P-13961 S4240 21731

NAME	DATE
(JINDAL)	JINDAL ALUMINIUM LTD.	DRAWN	J.P.KAUSHIK	01-08-2015
SYMBOL OF QUALITY	BANGALORE-560073 (INDIA)	CHECKED		
AN ISO 9001 COMPANY		APPROVED	S.S.GARG	17-08-2015
1. ALL DIMENSIONS ARE IN mm. 2. ROUND OFF ALL SHARP CORNERS WITH 0.40 mm. 3. TOLERANCES WILL BE AS PER IS:3965-1981 , UNLESS OTHERWISE SPECIFIED		SCALE		2:1
		AREA mm ²		187.028
		PERIMETER	mm.	293.888
PARTY'S NAME	PARAMOUNT INDUSTRIES, BANGALORE	WEIGHT kg/	/m	0.505
		DRAWING	No. SE	CTION No.
PARTY'S DRAWING No.	P-AL876113L & AS PER REQUIREMENT	P-13961 -		
	LIEO WD	S4240	S424	10(ISSUE-5)
ALLOY & TEMPER	HE9 WP	21731	21	1731
DESCRIPTION	WINDOW SECTION

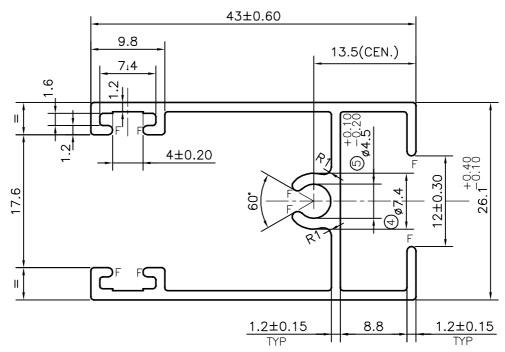
DIMENSIONS CHANGED FROM 25.6 TO 26.10 & 1.6 TO 1.85 WEIGHT ALSO CHANGED FROM 0.495 Kg/m TO 0.501 Kg/m ON DATED 20/01/2015

BEADING SHAPE CHANGE & TOLERANCE CHANGED 26.1±0.25 TO 26.1 WEIGHT ALSO CHANGED FROM 0.501 Kg/m TO 0.506 Kg/m

SCREW BOX OD DIA CHANGED FROM Ø7.0 TO Ø7.4 mm WEIGHT ALSO CHANGED FROM 0.506 Kg/m TO 0.512 Kg/m

SCREW BOX ID DIA CHANGED FROM Ø4.0 TO Ø4.5 mm & TOLERANCE ADDED WEIGHT ALSO CHANGED FROM 0.512 Kg/m TO 0.505 Kg/m
